Where's the Sealing Bolt in That Reman 9-Speed A/T?

AFFECTED VEHICLES

2016–17 Pilot Touring and Elite

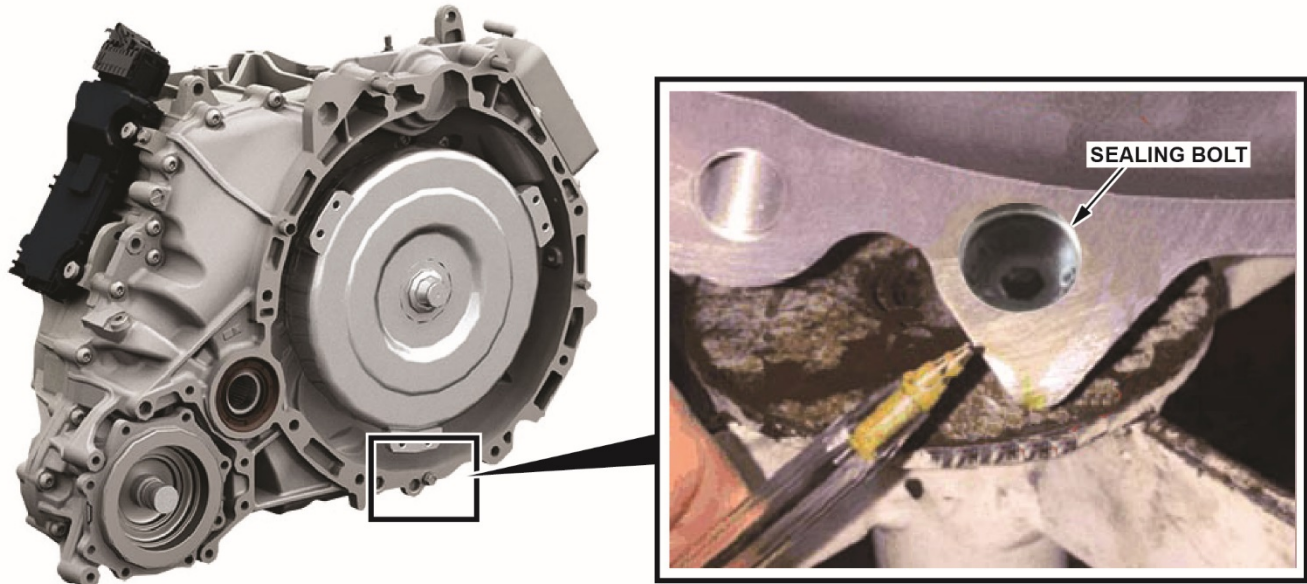
Because of a transmission case casting flaw, the inside of the torque converter bracket hole in some 9-speed A/Ts is porous enough that ATF could leak from the hole. This flaw was found by the transmission factory during production.

As a temporary fix, the factory installed a sealing bolt in that hole and it's proven effective. That casting issue has since been resolved, and later castings don't have that issue. So, the sealing bolt is no longer needed.

If you order a reman A/T and its serial number is **higher** than what's listed in this chart, don't worry about a missing sealing bolt. That A/T has a case that doesn't need it, so it doesn't come with one.

Model	Drive Type	Serial Number
2016–17 Pilot	2WD	Q5NB0116449
	4WD	Q5NC0133827
